**Report: TAB REPORT**  
**Function: Test, Adjust, & Balance**  
**Date: 08/05/2024**

**PROJECT**  
**07-01-24 CAVA CAMBRIDGE, MA (HARVARD SQUARE)**  
22 Brattle Street  
CAMBRIDGE, MA

## Project Summary

<b>Project:</b>	CAVA Harvard Cambridge MA		
<b>Tech:</b>	Dakota Olenik	<b>Date:</b>	07/08/24

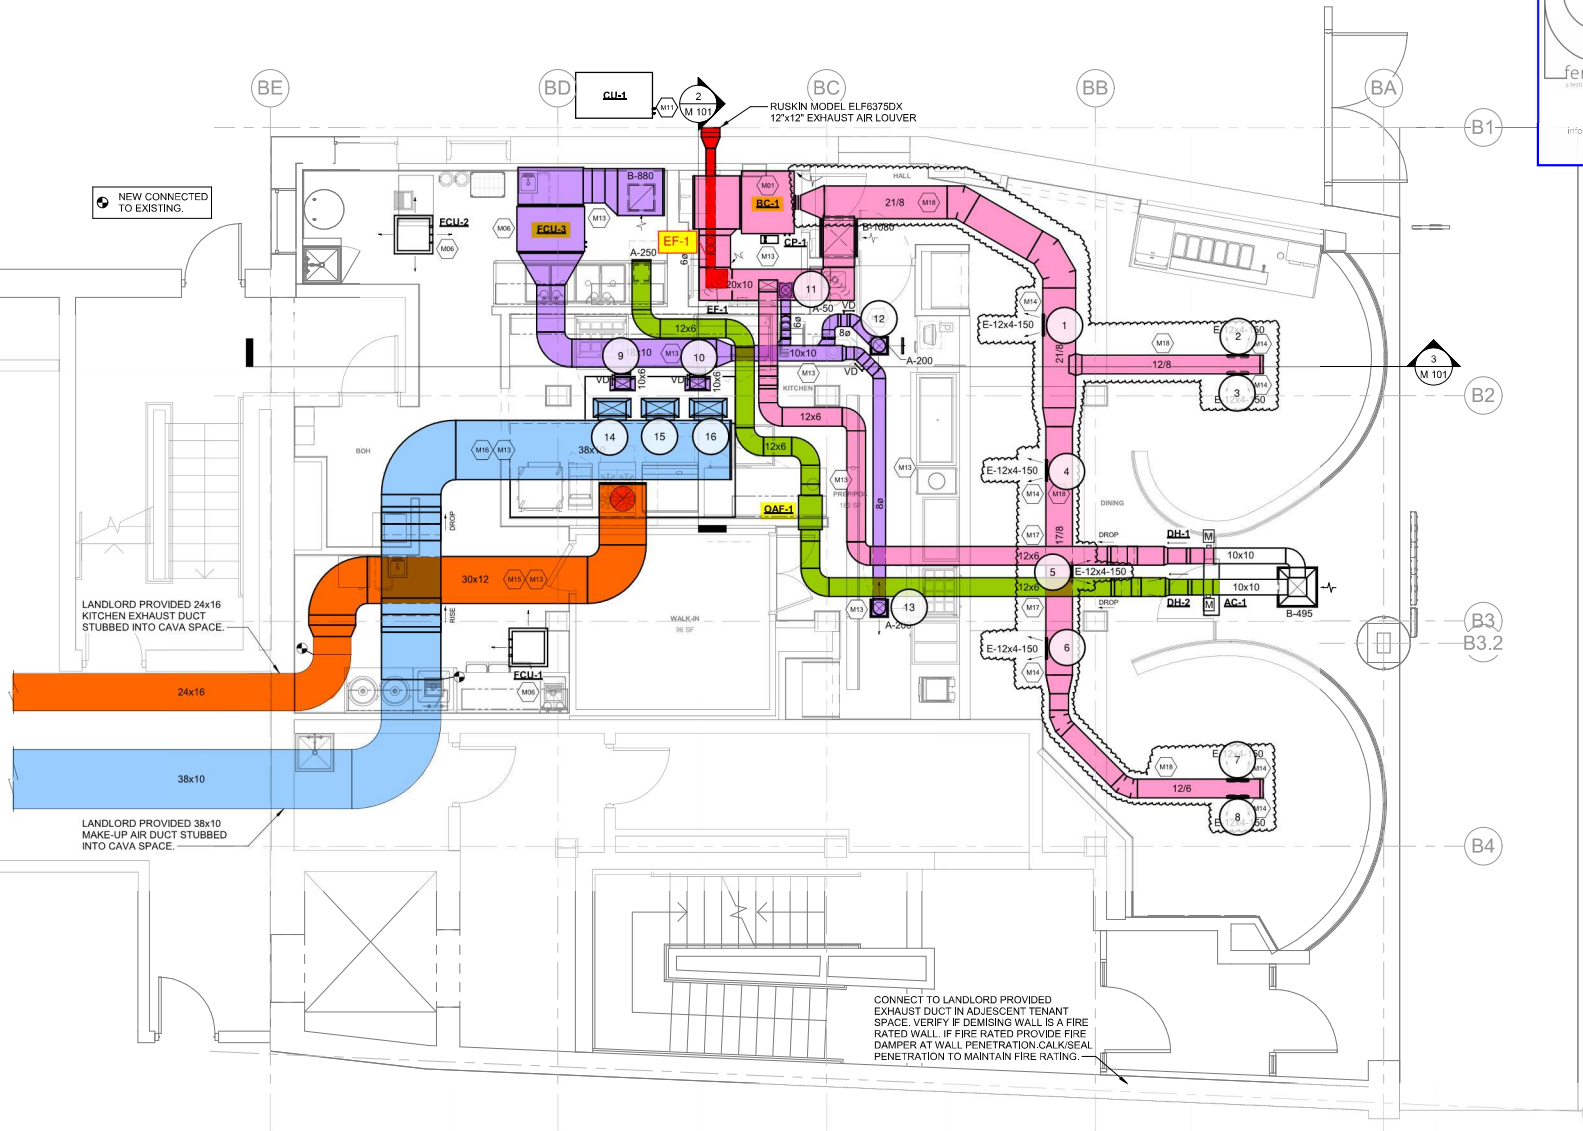
System	Notes
BC-1	Total air flow is at 85% of design; unit has very limited access could not evaluate condition of coil or filters. Unit is not cooling; RAT: 80F, SAT: 77F TD: 3.F; Balancing valve and PT ports not installed; could not access a section of pipe to achieve an ultrasonic reading; unable to measure water flow or temperatures; supply line was sweating, indicating it was cold. Could not determine control valve position; sweating indicated it was open. The CHW line did not have a strainer installed. Outside air flow not measured for this unit; see 'Outside Air'.
FCU-1	Cassette unit; airflow not measured. Unit is cooling: RAT: 73F, SAT: 52F TD: 21F.
FCU-2	Cassette unit; airflow not measured. Unit is cooling: RAT: 74F, SAT: 42F TD: 32F.
FCU-3	Airflow not measured; limited access provided to kitchen. Unit is cooling: RAT: 78F, SAT: 55F TD: 23F.
MAU-1	Airflow not measured; limited access provided to kitchen. Store pressure was neutral indicating MUA, OA and total exhaust were balanced.

OAF-1	Airflow not measured; limited access provided to kitchen; see 'Outside Air'. Store pressure was neutral indicating MUA, OA and total exhaust were balanced.
KEF-1	Airflow not measured; limited access provided to kitchen. Store pressure was neutral indicating MUA, OA and total exhaust were balanced.
EF-1	Total air flow is at 96% of design.
Outside Air	Total OA to BCU-1 and OAF-1 was measured at 106% of design.

1. The strainer for BC-1 needs to be cleaned and the chilled water coil needs to be backflushed to ensure it is clean.
2. The installing contractor needs to ensure the temperature control valve is functioning properly. In other words, when the unit is in cooling, the valve needs to open 100%.
3. If there continues to be problems, a balance valve needs to be installed to measure flow and temperature. It appears from the drawing that this was new piping so this should have been installed by the installing contractor anyway. An Autoflow valve is recommended for this application since you're tying into a larger building system.
